DATE ~~R~~ Oct.31/02**V2500-A5 PROPULSION SYSTEM SERVICE BULLETIN**

This document transmits Revision 2 to Service Bulletin EV2500-72-0314

ENGINE – CONVERSION – PROVIDE INSTRUCTIONS TO CHANGE THE V2500-A5 ENGINE START CRANK
BY MODIFYING THE DATA ENTRY PLUG

Data Entry Plug Assembly
Figure 2

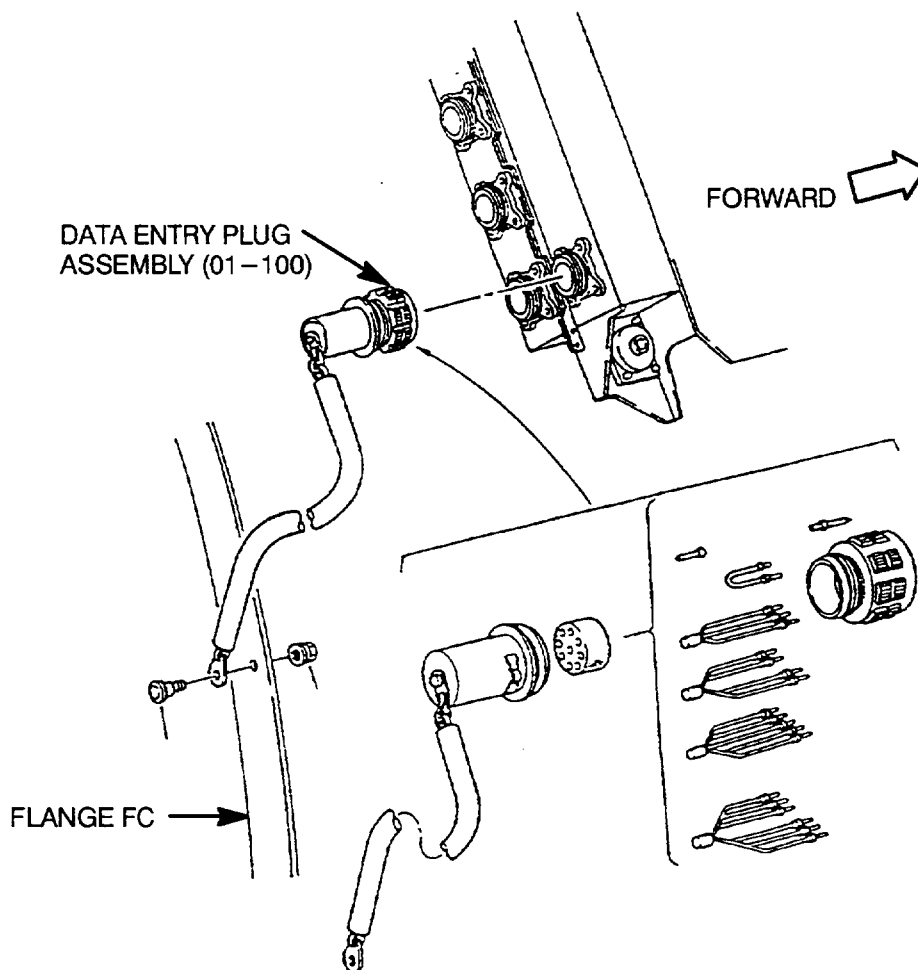
R (2) Disassemble the Data Entry Plug Assembly, PN 2A3106, (Reference (1),
R Chapter/Section 73-22-35, Figure/Item No. 01-100) by the procedure
R specified in Reference (2), Chapter/Section 73-22-35, Repairs, VRS3500 and
R Figure 2.

R (d) Determine the jumper pin changes required from these two copies, for
R the target engine Variant No. and any new jumpers needed, (Reference
R (1), Chapter/Section 73-22-35, Figure/Item No. 01-100), and Figure 2.

R (5) Assemble the Data Entry Plug Assembly by the procedure specified in
R Reference (2), Chapter/Section 73-22-35, Repairs, VRS3500 and Figure 2.

Identification of the Data Entry Plug Assembly to the new Part Number
Figure 3

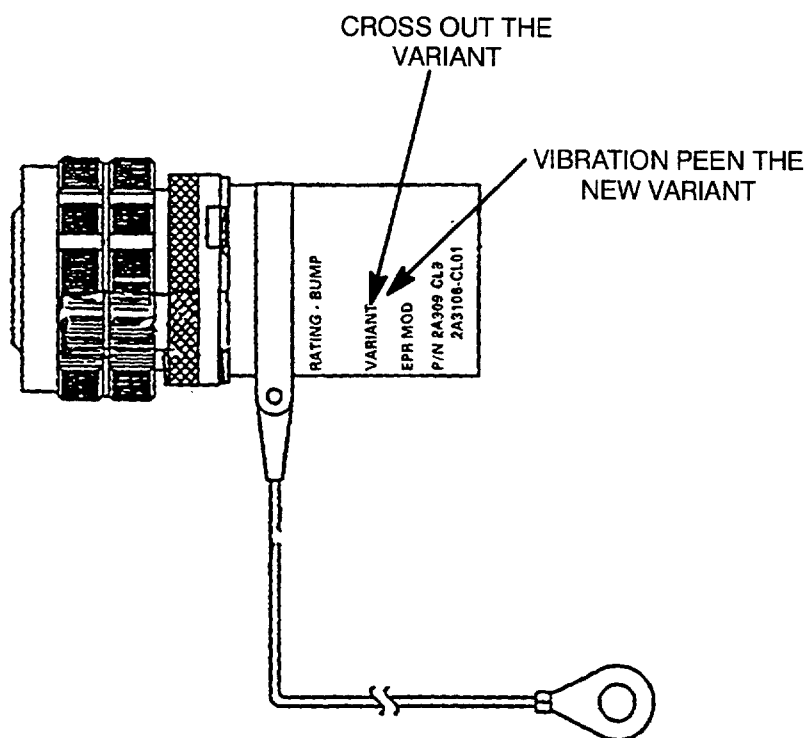
- R (7) Mark the Data Entry Plug Backshell with the new Variant No. by the
R procedure specified in Reference (3), Chapter/Section 70-09-00, Marking of
R Parts, and Figure 3. Use the vibration peen method.

Engine Identification Plate
Figure 4 (Sheet 1)

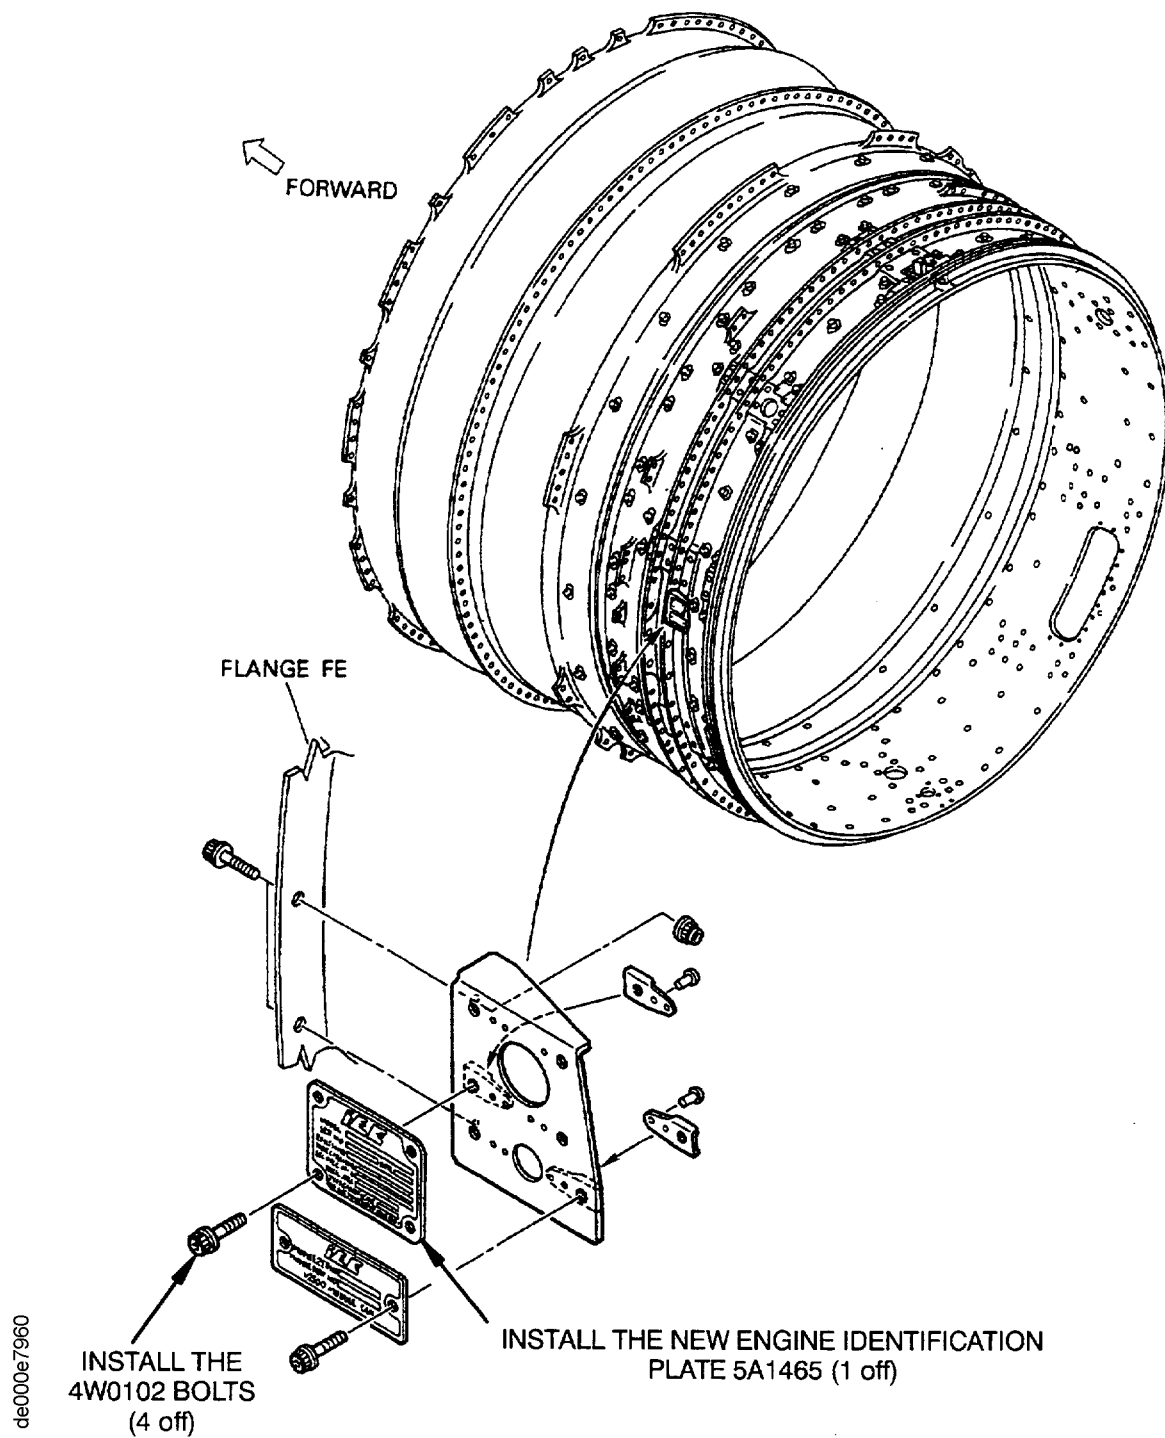
- R NOTE: Ensure that your IAE Representative is aware of the change in
R Engine Rating.
- R B. If Engine Identification Plate PN 5A1465, (Reference (1), Chapter/Section
R 72-32-85, Figure Item No. 03-120), and attached Figure 4 Sheet 1, is being
R replaced by the same PN Plate:

- R (1) Remove the four bolts (4W0102), that hold the Engine Identification Plate
R to the bracket.
- R (2) Permanently deface the old Engine Identification Plate and return it to
R your IAE Representative. Engine model and serial number must remain
R visible in order to allow verification by IAE Quality Assurance.
R Recommended technique is to vibropeen a wavy line through the Type
R Certificate and Production Certificate numbers.

- R (3) Get the new Engine Identification Plate from your IAE Representative.
- R (4) Install the new Engine Identification Plate with the 4W0102 bolts (4 off).

- R (5) Torque the 4W0102 Bolts between 36 - 45 lbfin (4,00 - 5,00 Nm).
- R C. If Engine Identification Plate PN 5A1465, (Reference (1), Chapter/Section
R 72-32-85, Figure Item No. 03-120), and attached Figure 4 Sheet 1, is being
R replaced by reusable Engine Identification Plate PN 5A1855 (Reference (1),
R Chapter/Section 72-32-85, Figure Item No. 03-120, and attached Figure 4 Sheet
R 2:

Engine Identification Plate
Figure 4 (Sheet 2)

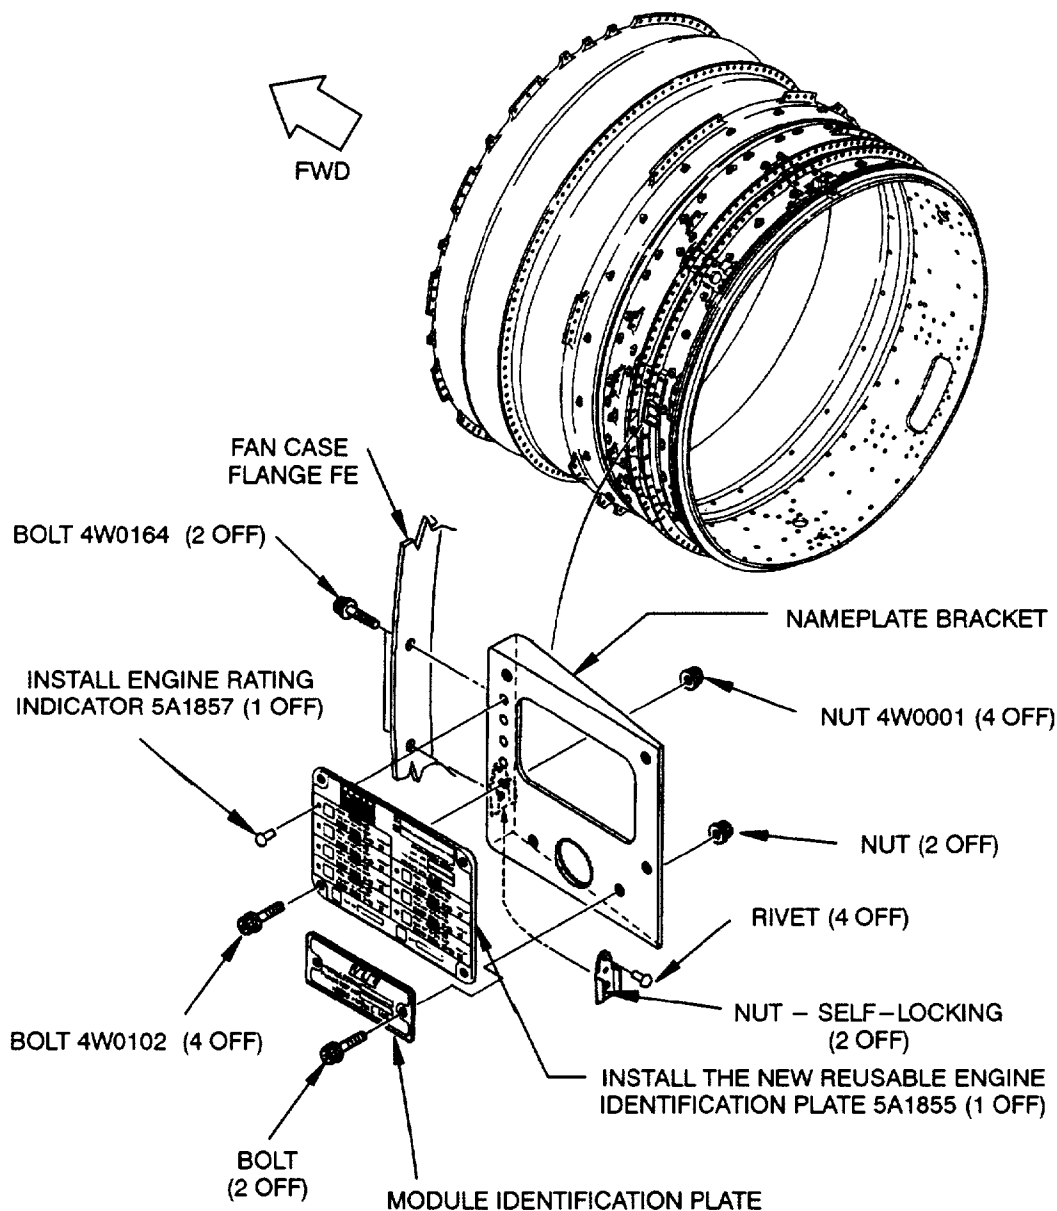
- R (6) Install the reusable Engine Identification Plate and bracket as per SB
R V2500-ENG-72-0378 (Reference 4).
- R (a) Install the Engine Identification Plate with the 4W0102 bolts (4 off)
R and the 4W0001 nuts (4 off).

- R (b) Torque the 4W0102 Bolts between 36 - 45 lbfin (4,00 - 5,00 Nm).
- R (c) Install the bracket with the 4W0164 bolts (2 off).
- R (d) Torque the 4W0164 Bolts between 85 - 105 lbfin (10,00 - 12,00 Nm).

- R D. If reusable Engine Identification Plate PN 5A1855, (Reference (1),
R Chapter/Section 72-32-85, Figure Item No. 03-120), and attached Figure 4 Sheet
R 2, is being replaced by the same PN plate:

Engine Identification Plate
Figure 4 (Sheet 3)

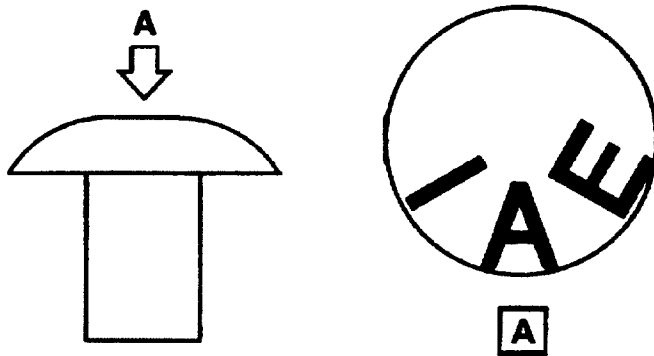
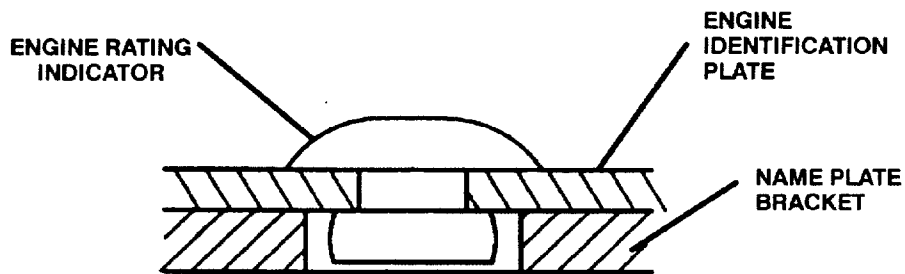
- R (3) Get the new reusable Engine Identification Plate PN 5A1855 and bracket
R from your IAE Representative.
- R (4) Get the Engine Rating Indicator (IAE Rivet) PN 5A1875 (Reference (1),
R Chapter/Section 72-22-36, Figure Item No. 01-100), and attached Figure 4
R Sheet 3.

- R (a) Drill a hole 0.098 - 0.101 inch (2,5 - 2,56 mm) diameter at the circle
R marked on the Engine Identification Plate at the designated rating,
R and deburr.

- R (b) Install the Engine Rating Indicator (IAE Rivet) PN 5A1875 through the
R Engine Identification Plate at the designated Rating and squeeze with
R the power riveter.

Contact Hole Locations
Figure 5

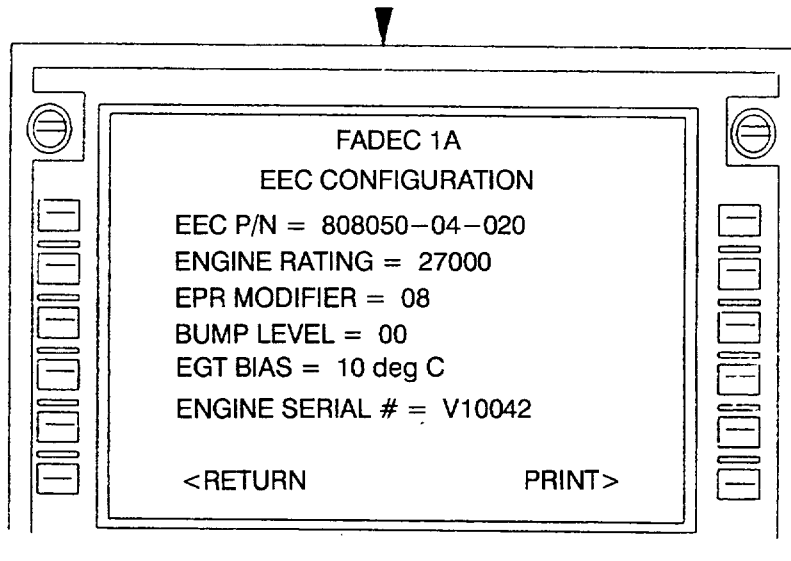
R (3) Make two copies of Figure 5, Contact Hole Locations.

R (a) Mark the existing jumper connections from the Data Entry Plug
R Connector on one copy of the figure.

R (b) Find the jumper pin connections, from Table 1, for the current Variant
R No. and highlight these on the copy made in A. (3).

R (c) Find the jumper pin connections, from Table 1, for the Variant No. for
R the target Start Crank and highlight these on the second copy of the
R figure.
